SERVICE BULLETIN: JSB 013-1

Date: 8th August 2006

Subject: Jabiru 2200 Engine Rocker Chamber Vent

Figure 1. Vent Position – View Looking Parallel to Valves

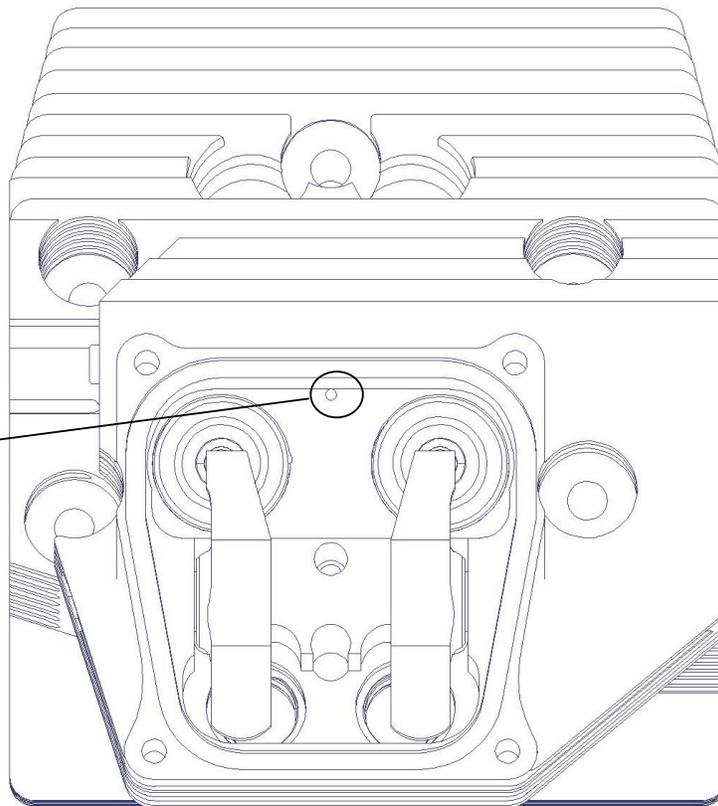
Vent hole located midway between valves at the top of the rocker cavity.

- i) With reference to the engine's Instruction & Maintenance Manual, remove the aircraft cowls and engine ram-air ducts.
- ii) Remove the rocker covers from the engine.
- iii) Locate the position shown in Figure 2 below and use a small centre punch to mark the hole position.
- iv) Using a 3/32" drill bit, drill a hole in the head as shown. The hole must angle upwards to encourage oil to flow back into the rocker cavity instead of out into the engine bay. Before drilling, coat the tip of the drill bit with grease to catch the aluminium shavings from the hole. Drill in stages, cleaning and re-greasing the drill every second or two. Ensure that no loose shavings escape into the rocker cavity.
- v) Replace the rocker covers re-assemble the aircraft.

Figure 2. Sectioned View of Head Assembly – Hole Shown.

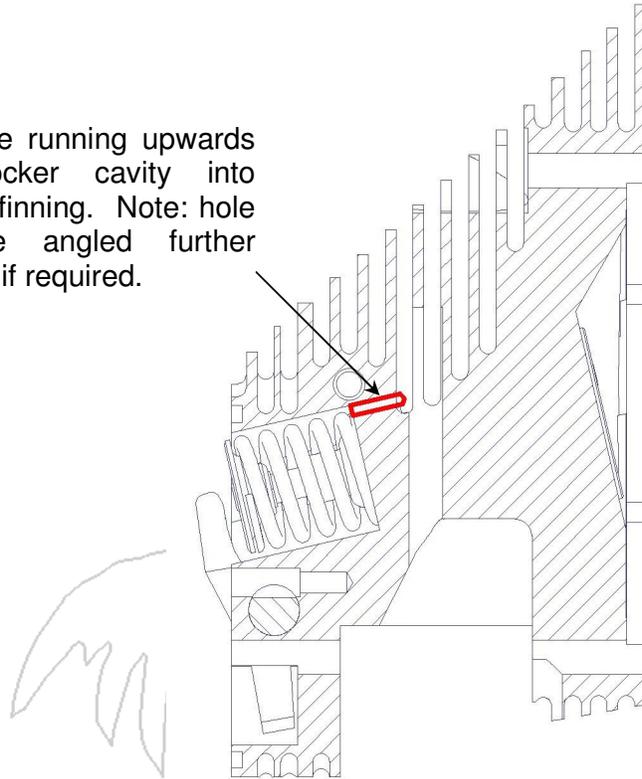
Vent hole running upwards from rocker cavity into external finning. Note: hole may be angled further upwards if required.
